EXPERT PANEL FINAL REPORT

REVIEW OF PHASE 2 TREATABILITY STUDY AEROJET FACILITY RANCHO CORDOVA, CALIFORNIA

July 2001

FIGURE 1

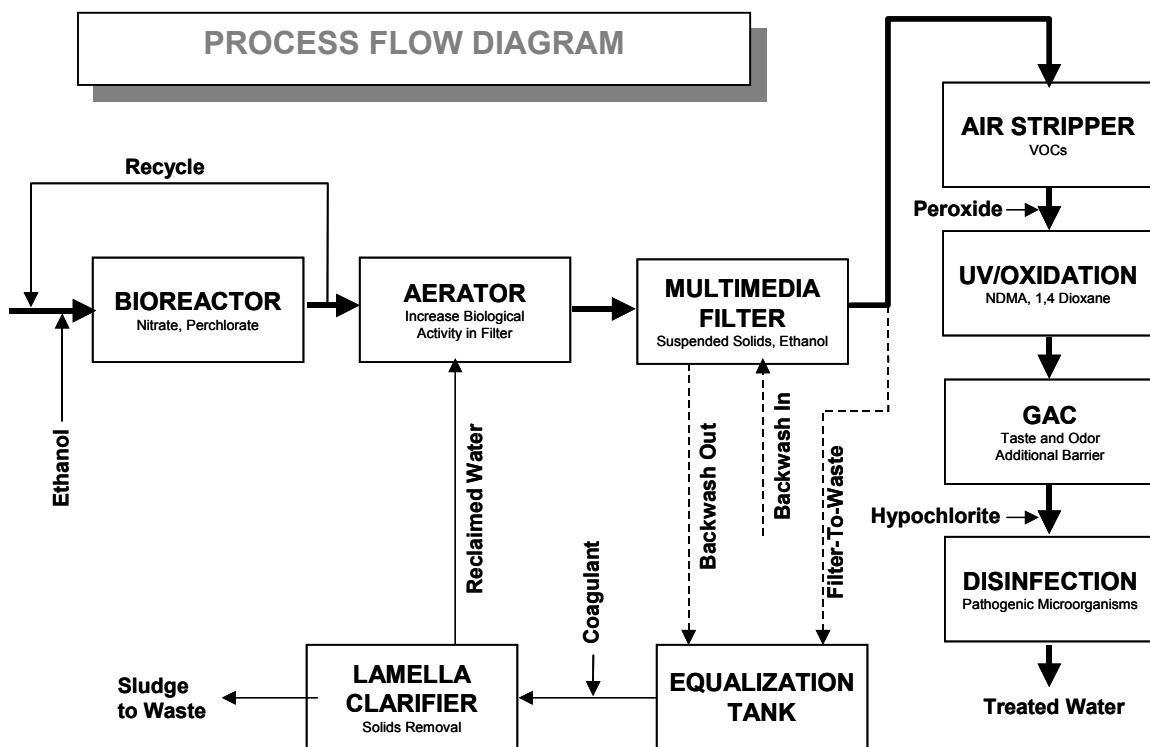
Biological Process for Perchlorate Removal: The biological process, consisting of an upflow fluidized bed of granular activated carbon, operated as an anoxic fixed film reactor, with ethanol as the carbon feed source, was effective at removing perchlorate ion to below detection limits. Provided that the ethanol feed rate was maintained in an optimum operating range, and the flow and water quality were relatively constant, the system performed very reliably. With appropriate process control and monitoring features, a full-scale system has a high probability of meeting

Granular Media Filtration: The multimedia filter has been reliable and was able to meet all required effluent targets for turbidity. Because this is a well-demonstrated technology, there are few uncertainties regarding the ability of this process to produce water that would meet typical potable treatment requirements, provided that the headloss used in the design does not exceed that employed during the pilot studies. A design based on the longer filter runs would require pilot scale confirmation to ensure that turbidity breakthrough will not occur. Typical future challenges that should easily be controlled by the filter include periodic spikes from the biological process and the corresponding response of filter controls and/or operators to mitigate the impact of the spikes. Redundancy in the final design should be considered.

Air Stripping: The air stripping system using a low profile five-tray air stripping device was very effective at decreasing both TCE and chloroform and all other VOCs that were present at low concentrations. Although the reliability of a full-scale packed tower system cannot be determined quantitatively from the current tray tower system, no scale-up problems are likely based on extensive experience in the water treatment industry with numerous water treatment applications of packed tower air strippers to remove chlorinated solvents. At scale up, appropriate ranges of water temperature, optimal air to water ratios as well as off gas treatment should be considered.

Advanced Oxidation: The advanced oxidation system consisting of UV/hydrogen peroxide (UV/OX) met NDMA and 1,4-dioxane targets with the air stripper in operation. The report indicates that scaling on the UV lamps will not be a problem at the Sacramento site and that the process can provide reliable performance. Scale up should include proper baffling at the entrance and exit as well as within the unit.

Granular Activated Carbon: Liquid phase GAC will function both as an adsorber and as a biological process depending on the circumstances. If an upstream process fails, GAC provides an additional barrier for VOC removal. GAC also provides control of taste and odor producing compounds, a reduction in assimilable organic carbon (AOC) and DBP precursors. Scale-up issues include how to move carbon through the system for regeneration. There are benefits of using available modeling tools to assist in scale up decisions.

Chlorine Disinfection: The disinfection requirements in the study protocols have been met for this process train, provided a chlorination system is designed for the effluent that can reliably achieve the appropriate concentration/time values for all microbial contaminants of concern.
